HUNTS POINT INTERSTATE ACCESS IMPROVEMENT PROJECT – CONTRACT 3

PIN X731.65, Contract D900055

Addendum #10

August 5, 2022

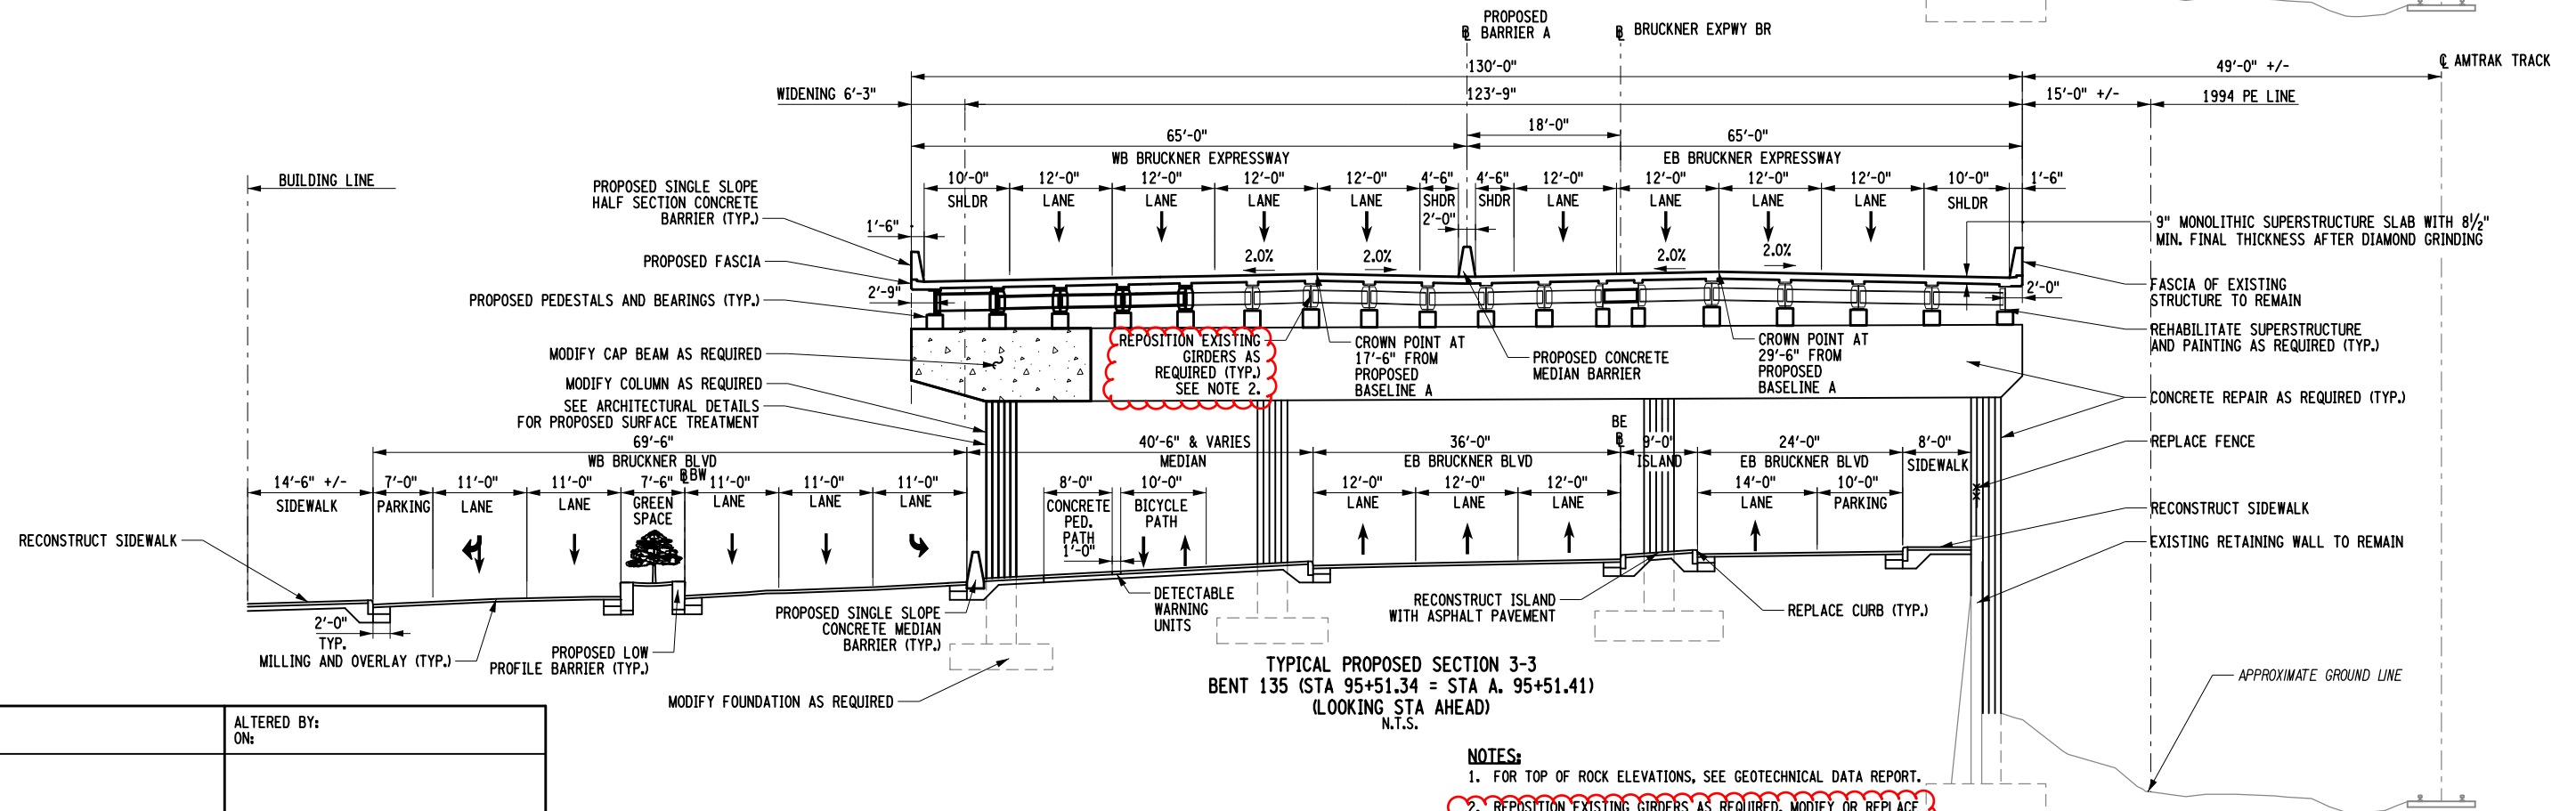
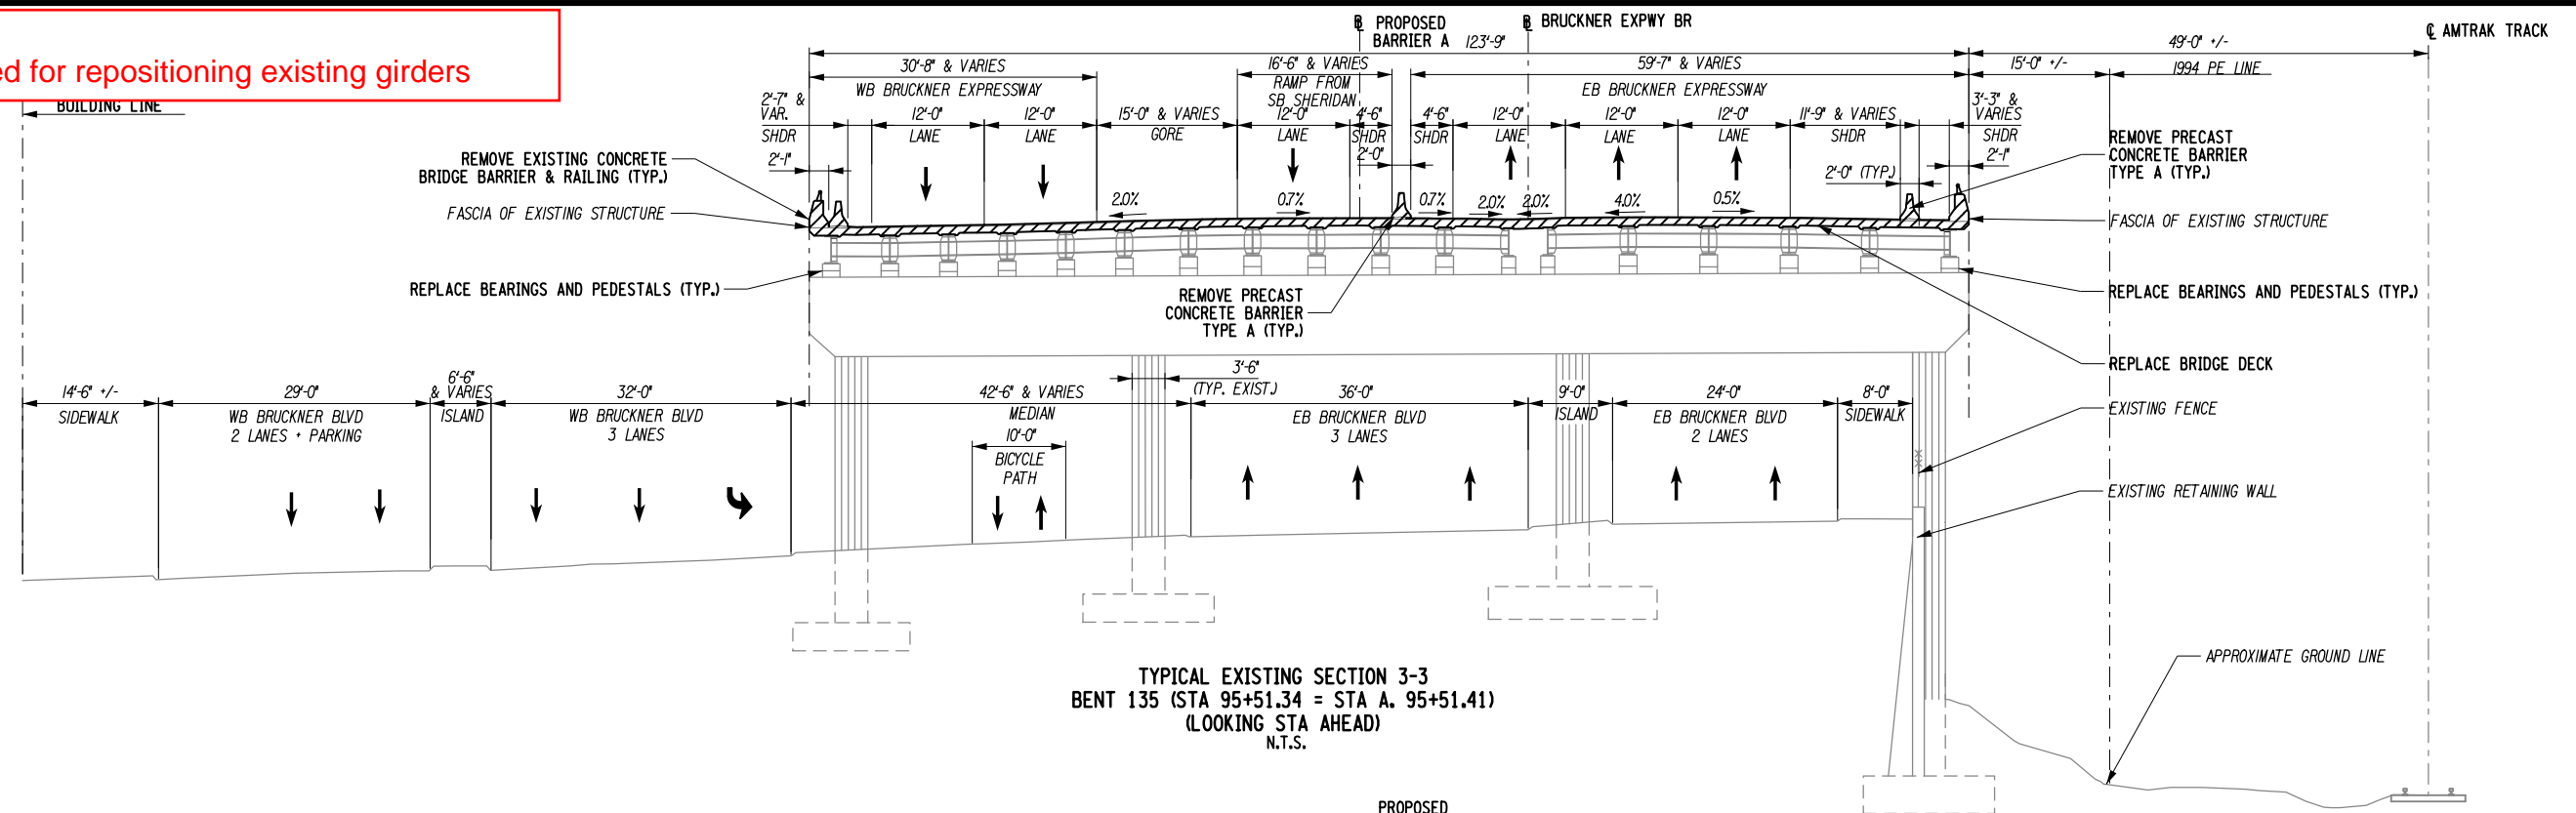
1. FOR TOP OF ROCK ELEVATIONS, SEE GEOTECHNICAL DATA REPORT.
2. REPOSITION EXISTING GIRDERS AS REQUIRED. MODIFY OR REPLACE EXISTING DIAPHRAGMS AND THEIR CONNECTIONS AS REQUIRED TO ACCOMMODATE CHANGES IN THE ROADWAY GEOMETRY.

Revisions:
- Note and callout added for repositioning existing girders

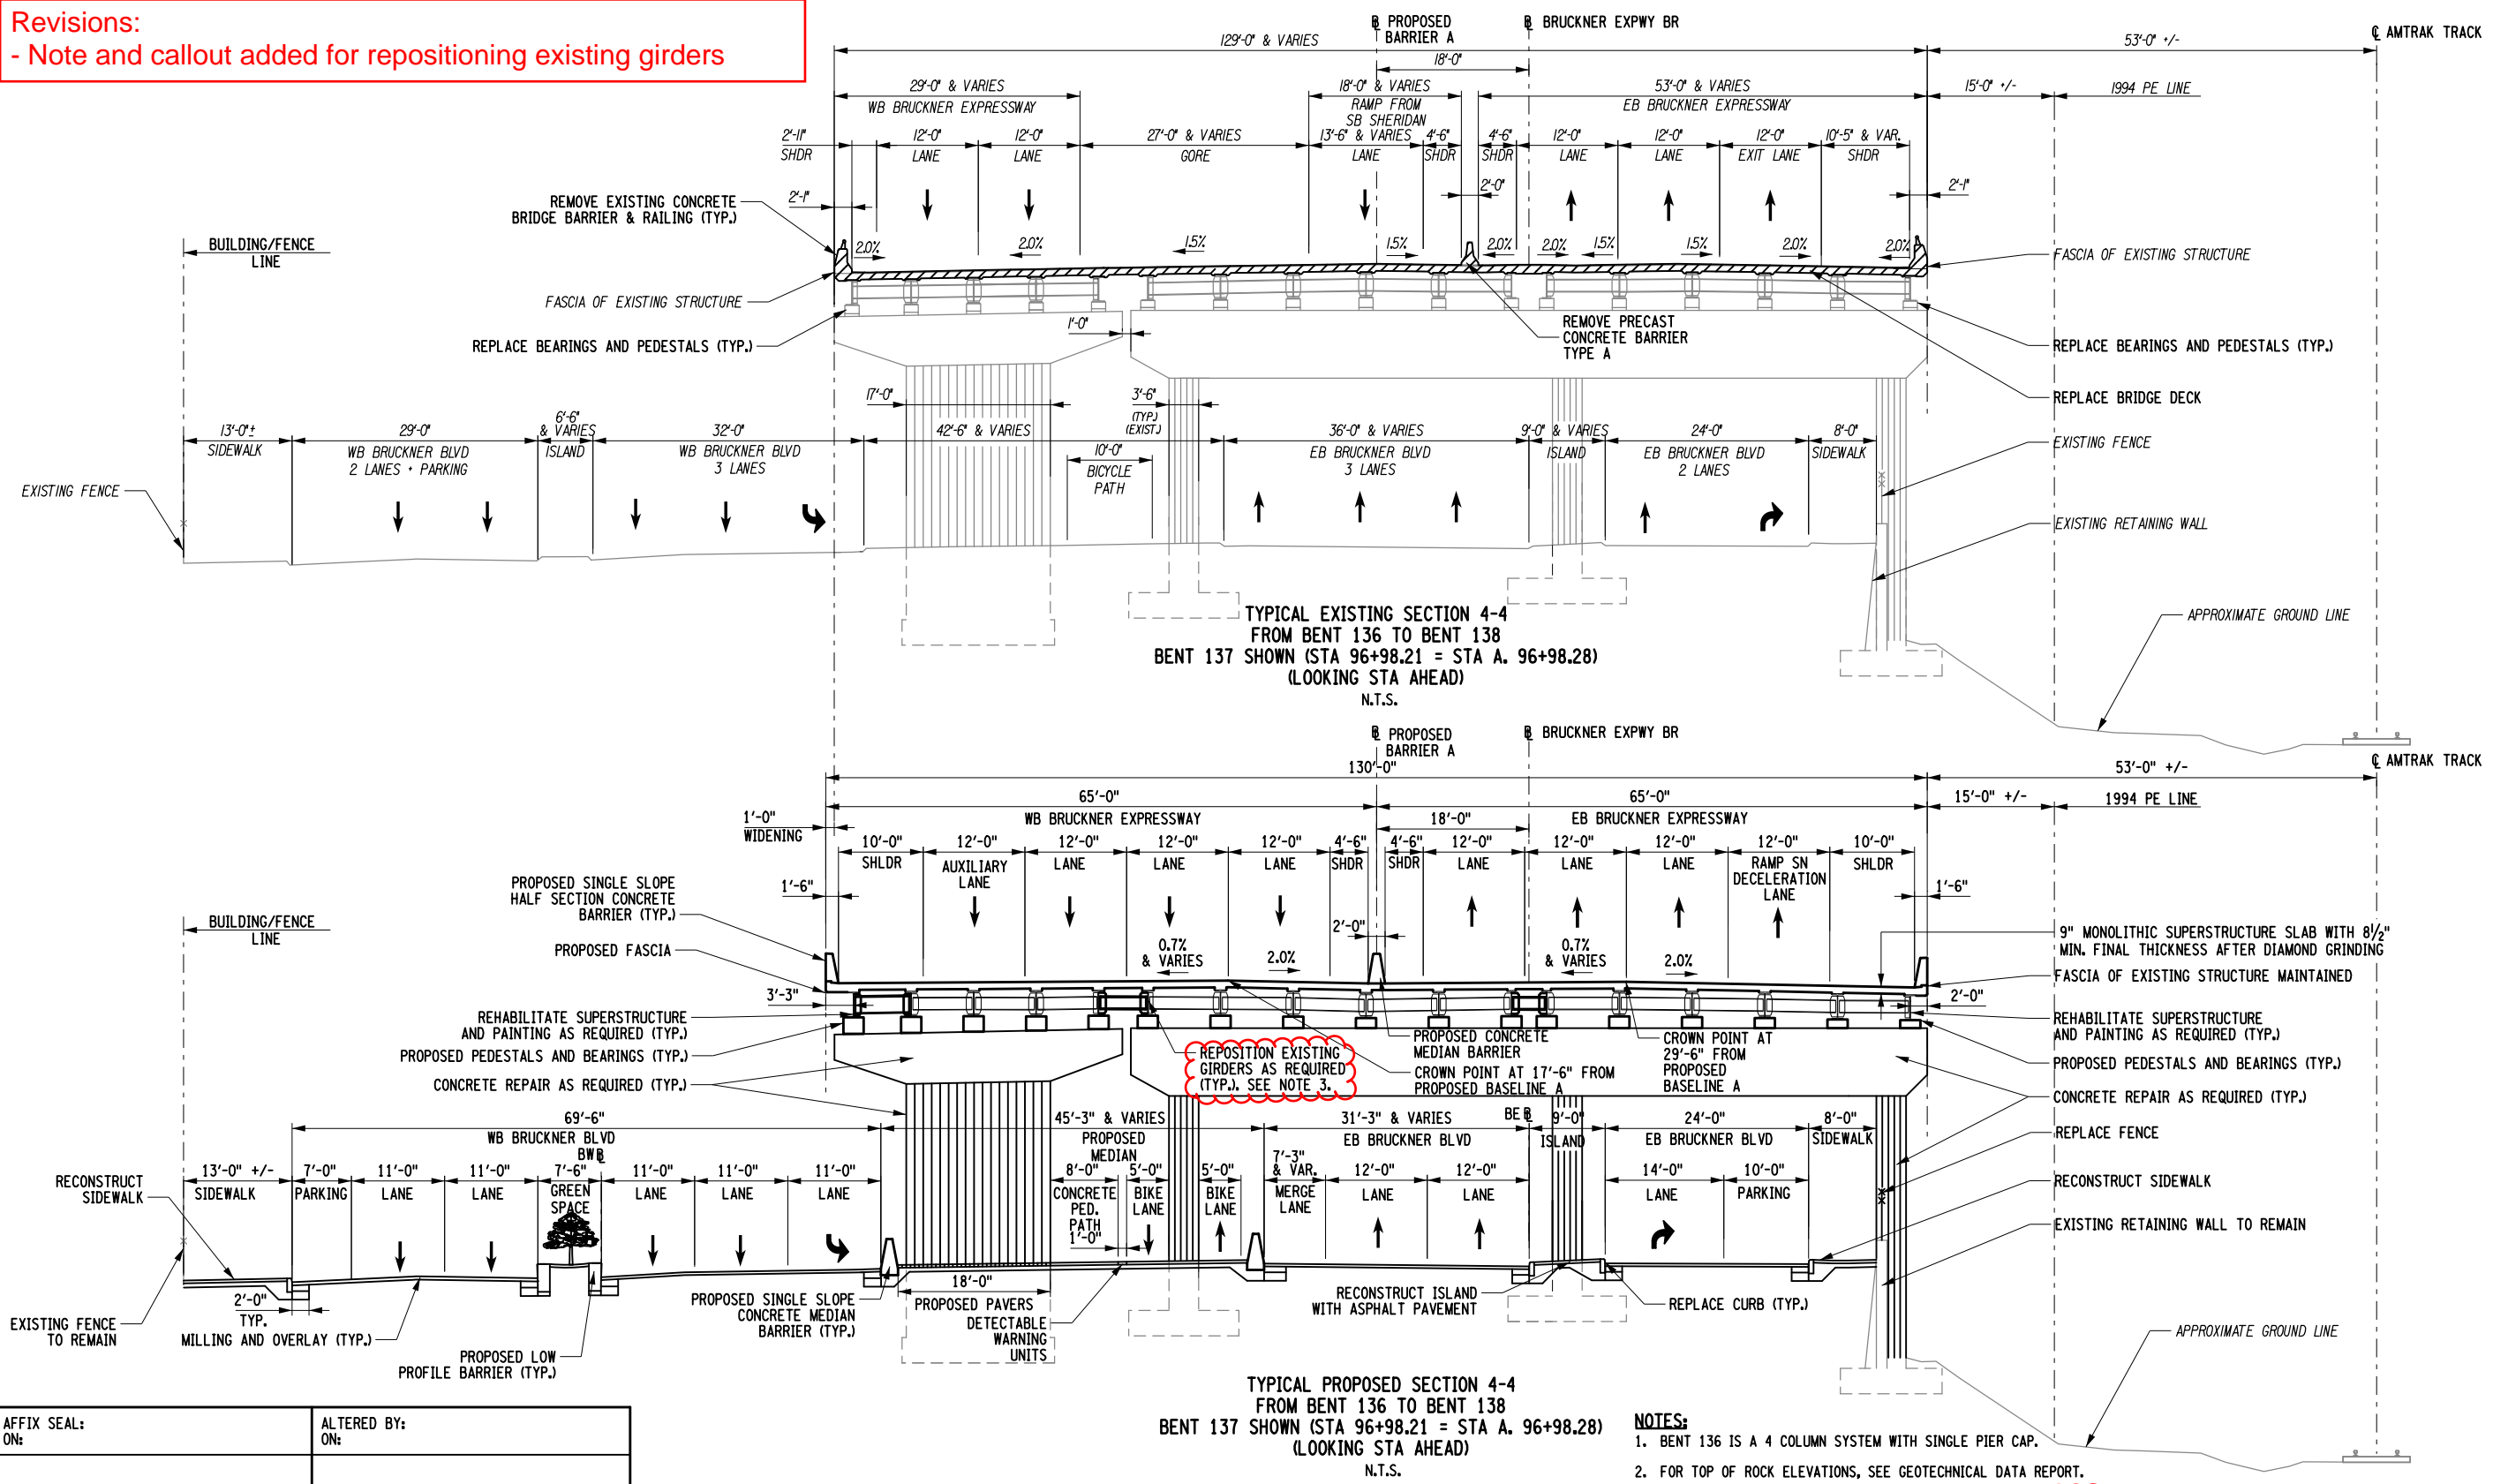
Revisions:
- Note and callout added for repositioning existing girders

- NOTES:
- 1. BENT 136 IS A 4 COLUMN SYSTEM WITH SINGLE PIER CAP.
 - 2. FOR TOP OF ROCK ELEVATIONS, SEE GEOTECHNICAL DATA REPORT.
 - 3. REPOSITION EXISTING GIRDERS AS REQUIRED. MODIFY OR REPLACE EXISTING DIAPHRAGMS AND THEIR CONNECTIONS AS REQUIRED TO ACCOMMODATE CHANGES IN THE ROADWAY GEOMETRY.
